Drawing Change Notice

CHANGE DOCUMENT NO.
24590-PTF-VDCN-MS-10-00008

JOB NO.	TITLE FOR CHANGE NOTICE
24590	UFP-VSL-00062B Redesign

JUSTIFICATION FOR CHANGE	CAUSE CODE
Based on the re-analysis of UFP-VSL-00062B, per calculation 24590-PTF-MVC-UFP-00023, for revised seismic conditions and design evolution, required a redesign of the vessel.	01 and 23

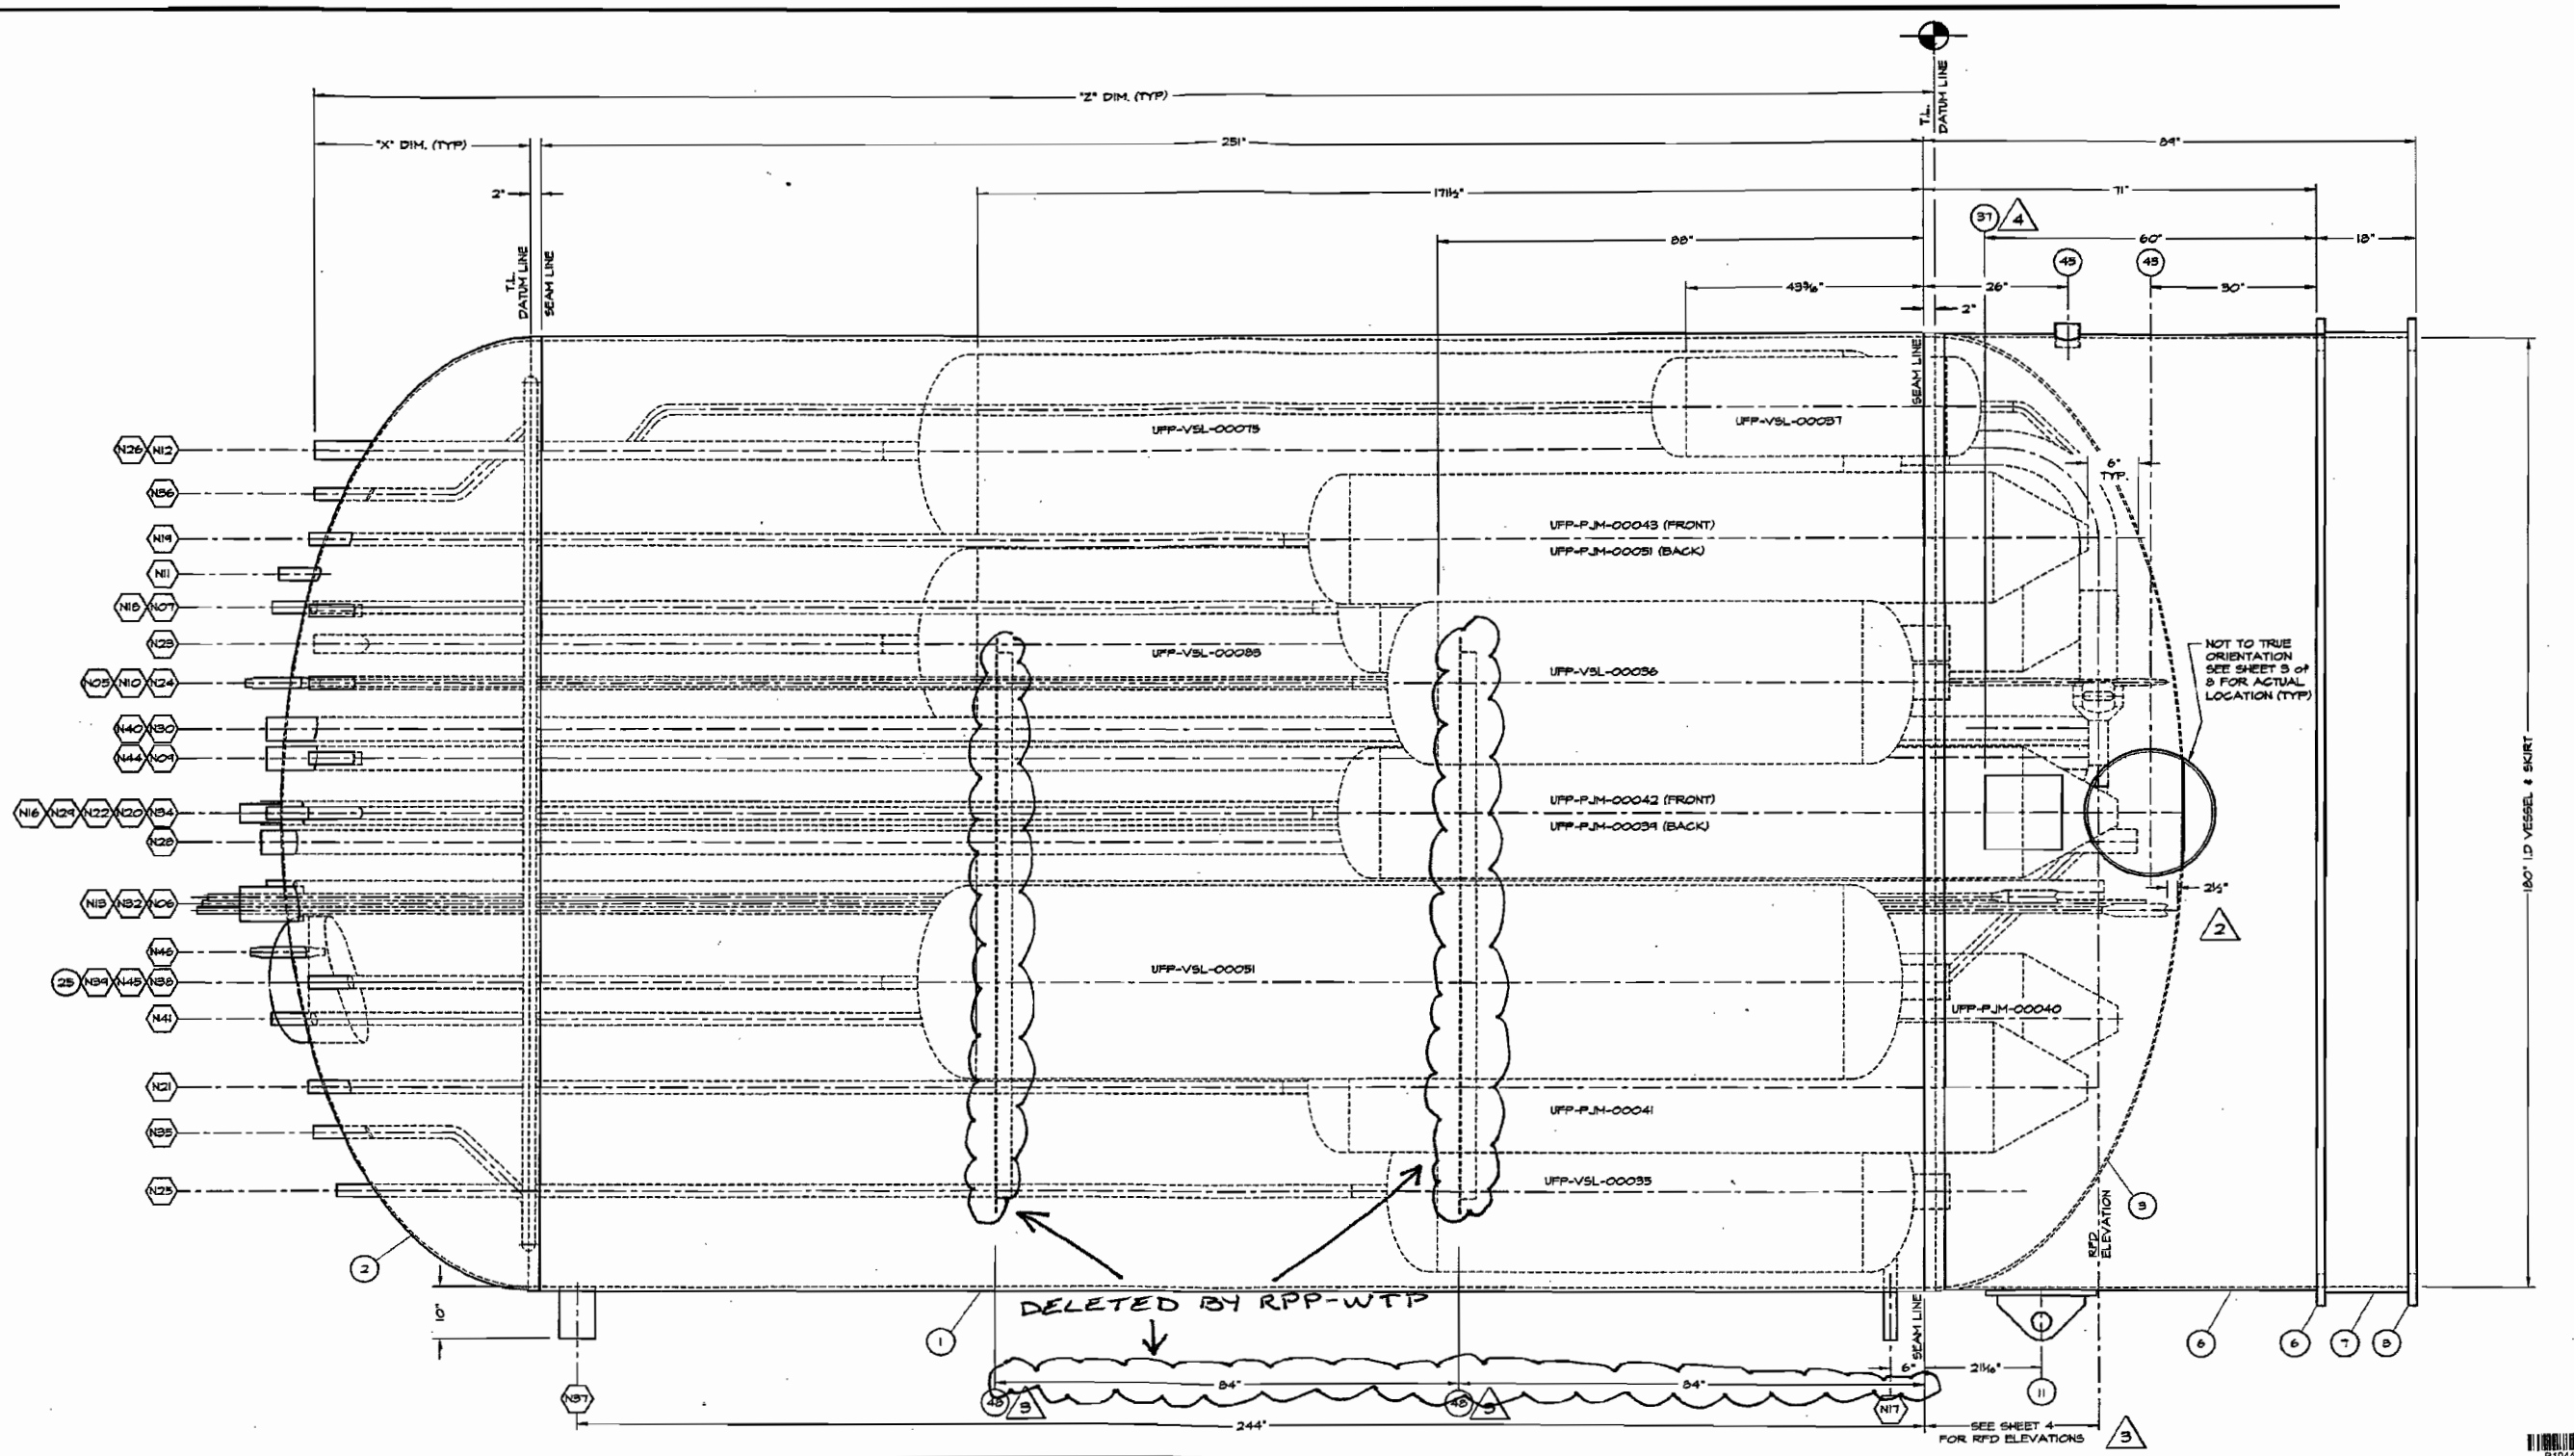
1. **Affected Document: 24590-QL-POD-MVA0-00001-03-04 (see Attachment 1, page 1 of this VDCN).**

a.) Design Conditions block: Change 'Design Pressure' to 15 / -2.0

b.) Design Conditions block: Change temperature to 230°F.

c.) Bill of Materials block: Delete the following Line Items:

d.) Bill of Materials block: Add item 59 and 60 shown on Attachment 1, page 16 of this VDCN.

f.) General Notes and Special Requirements: Delete Note 8 and replace with the following text:

h.) Connection Schedule block: Change the 'NECK THK' to SCH 160 for the following nozzles:

i.) Connection Schedule block: Change the 'NECK MATERIAL' to SA312 TP316/316L 0.030% MAX C for the following nozzles:

j.) RT per ASME Section VIII Div.1 Appendix 4 block: Change Appendix 4 to read "UW-51".

k.) Under title block, delete BNI reference drawing entitled, "REF DWG 24590-PTF MV-UFP-00006 REV 0".

Fabrication tolerances for field modifications shall be per 24590-WTP-MV-M59T-00001 (Pressure Vessel Tolerances Standard Details) and PFI Standard ES-24 (Pipe Bending Methods, Tolerances, Process and Material Requirement). For tolerances not specified by these standards, the following shall apply, unless otherwise noted:

Dimension	Tolerance
Linear < 12 inch	± 1/8 inch
Linear ≥ 12 inch	± 1/4 inch
Angular	± 2 degrees

CHANGE N07, N10 AND N36 MATERIAL TO SA312 TP316/316L 0.030% MAX C, BY RPP-WTP

CHANGE N07, N10, AND N36 TO SCH 160, BY RPP-WTP

SPECIFICATIONS	PARENT VESSEL
DESIGN PRESSURE	~~15/-10.29 psig~~ 15/-2.0 BY RPP-WTP
HYDRO-TEST PRESSURE	19.5 psig + 15.5 psig S.H.
DESIGN TEMPERATURE	~~120°F~~ 230°F BY RPP-WTP
MDMT	40° F.
CODE	ASME SECTION VIII, DIVISION I, 2001 EDITION, 2001 ADDENDUM
CODE STAMP (National Board No.)	REQUIRED
NON-DESTRUCTIVE TESTING	VT, UT, PT, RT, HELIUM TESTING, AND HYDROSTATIC TESTING PER ASME SECT. VIII, DIV. I
RADIOGRAPH (5)	PER PARA. 6.5.5 OF SPECIFICATION 24590-WTP-3PN-MV00-00006
JOINT EFFICIENCY	PER UW-12
CORROSION ALLOWANCE	0.04"
INSPECTION OPENING	REQUIRED PER UG-46(a)
IMPACT TESTING	NOT REQUIRED PER UHA-51(d)
POSTWELD HEAT TREATING	NOT REQUIRED PER UHA-32
MATERIAL: BOLTS/STUDS/NUTS	NOT APPLICABLE
MATERIAL: GASKETS	NOT APPLICABLE
INSULATION	NOT REQUIRED
WIND DESIGN	NOT REQUIRED
SNOW DESIGN	NOT REQUIRED
SEISMIC DESIGN	SC-I PER 24590-WTP-3PS-MV00-T0002 & 24590-WTP-3PS-SS90-T0001
BECHTEL QUALITY LEVEL	QL-I

(3) DELETE LINE ITEMS 46, 49, 54, 55, 58 BY RPP-WTP. NOTE ITEM 49 IS DELETED AS REQUIRED.
ADD ITEM 59, BY RPP-WTP
ADD ITEM 60, BY RPP-WTP

CHANGE TO UW-51 BY RPP-WTP

OPERATING: 512,285 lbs
FULL WATER: 401,100 lbs
EMPTY: 103,000 lbs
BY RPP-WTP

2 1A VESSEL ELEVATION
SCALE: ¾" = 1'-0"

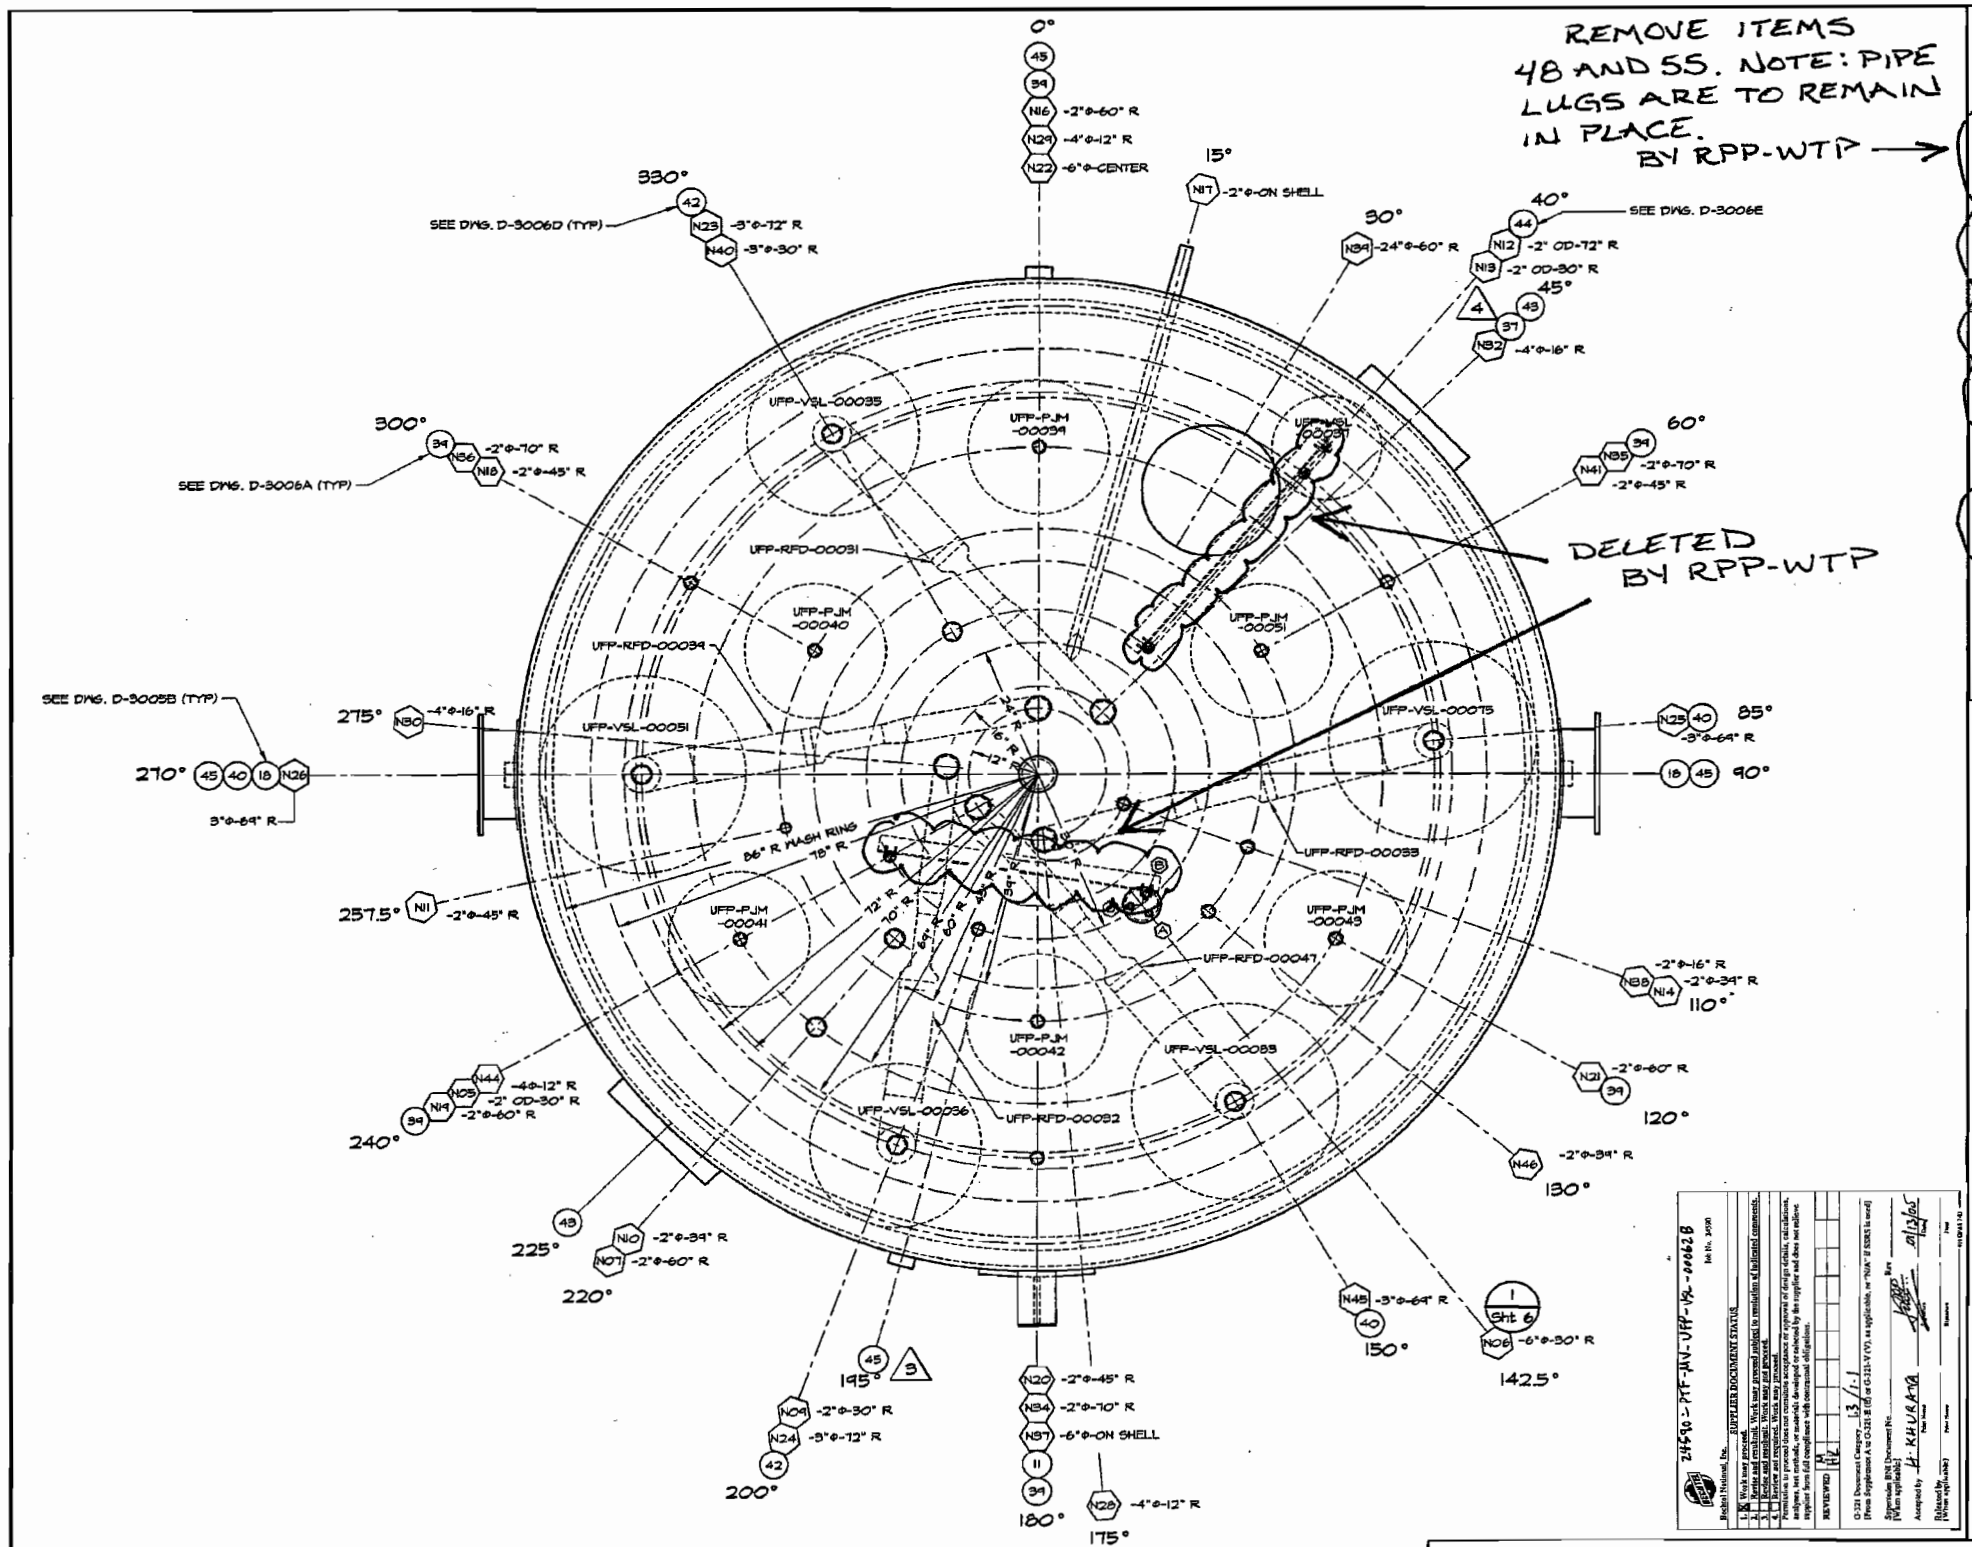
2. **Affected Document: 24590-QL-POD-MVA0-00001-03-05 (see Attachment 1, page 2 of this VDCN).**

a.) Vessel Elevation View:

(1.) Delete supports and associated part bubbles depicted on drawing.

(2.) Delete support dimensions depicted on drawing.

(3.) Under title block, delete BNI reference entitled, "REF DWG 24590-PTF MV-UFP-00006 REV 0".

3 INTERNAL PIPE BRACE DETAILS
SCALE: ⅜" = 1"

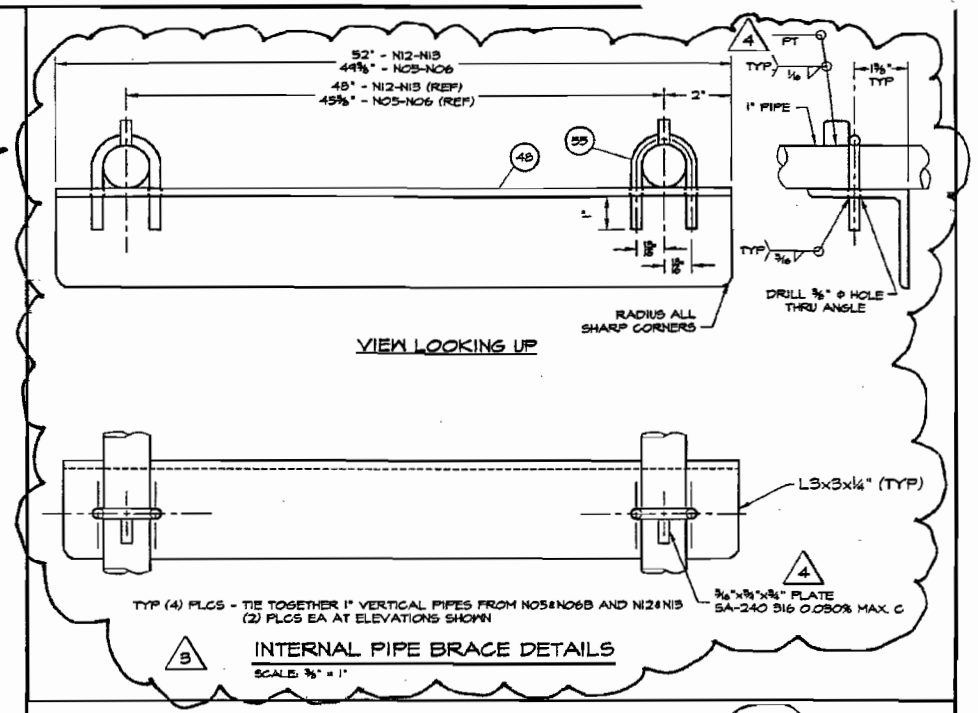
b.) Internal Pipe Brace Details: Remove items 48 and 55. NOTE: Pipe Lugs are to remain in place.

REMOVE ITEMS 48 AND 55. NOTE: PIPE LUGS ARE TO REMAIN IN PLACE. BY RPP-WTP →

5 INTERNAL PIPE BRACE DETAILS
SCALE: ⅜" = 1'-0"

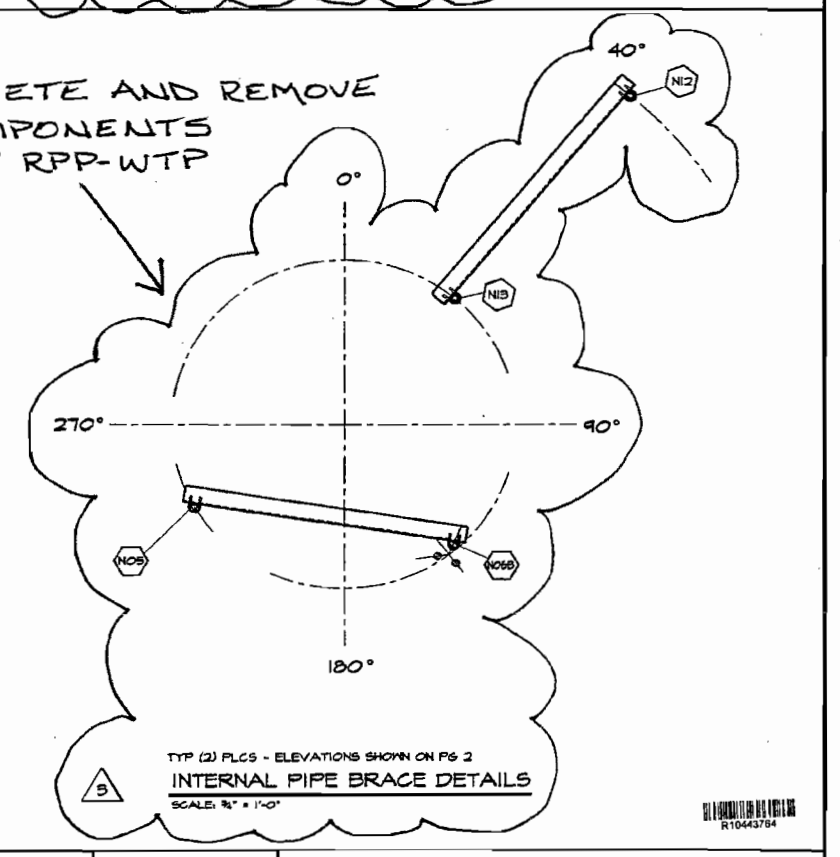
c.) Internal Pipe Brace Details: Delete detail and remove components.

DELETE AND REMOVE COMPONENTS BY RPP-WTP
